**APPLICATION FOR PERMISSION
UNDER SECTION 16 OF
THE TOWN PLANNING ORDINANCE
(CAP. 131)**

For Official Use Only 請勿填寫此欄	Application No. 申請編號	A/K5/889
	Date Received 收到日期	24 OCT 2024

**Section 16 planning application for proposed columbarium
at Lot NKIL 6071 (Portion) & STT KX1603 (Portion),
Ching Cheung Road**

Response to comment

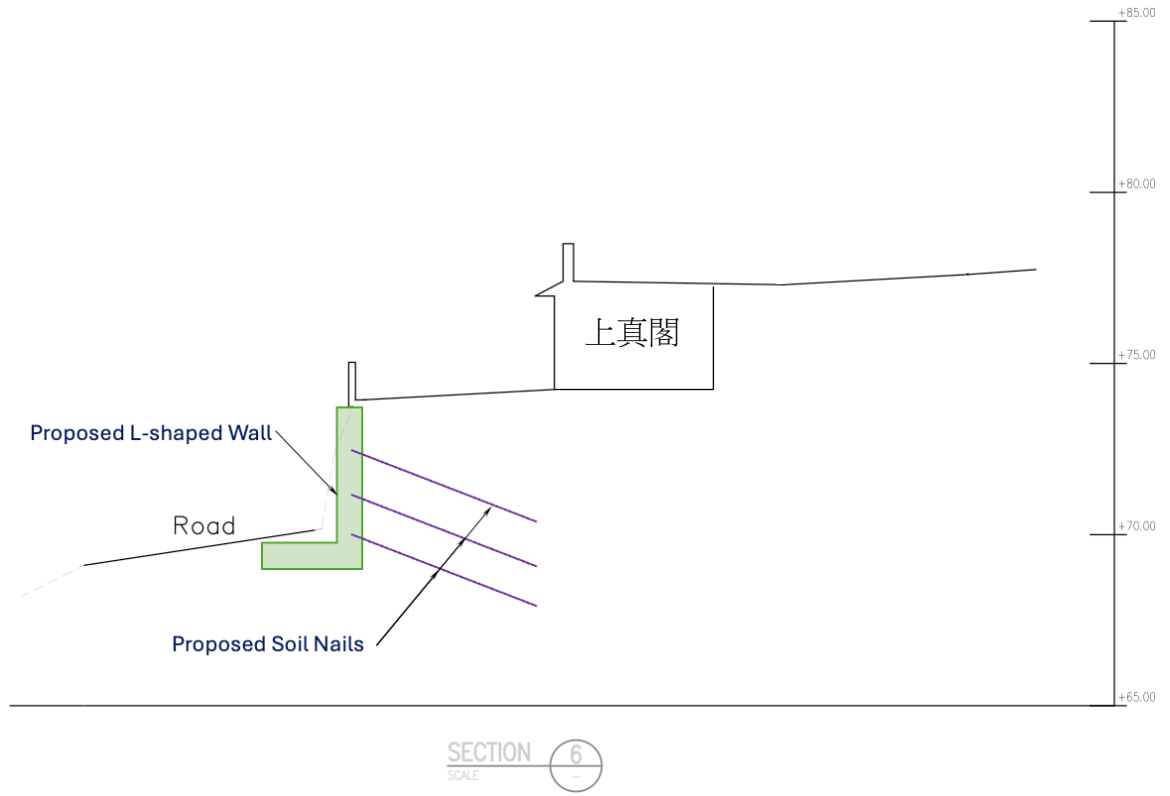
- (h) to note the comments of the Head of the Geotechnical Engineering Office, Civil Engineering and Development Department that the approval shall be granted with a condition that a detailed geotechnical assessment and necessary upgrading works shall be carried out for the slope feature No. 11NW-A/C445 at the back of Chap Tak Hall and the unregistered geotechnical feature supporting Sheung Tsang Hall as stated in the “Geotechnical Planning Review Report”.
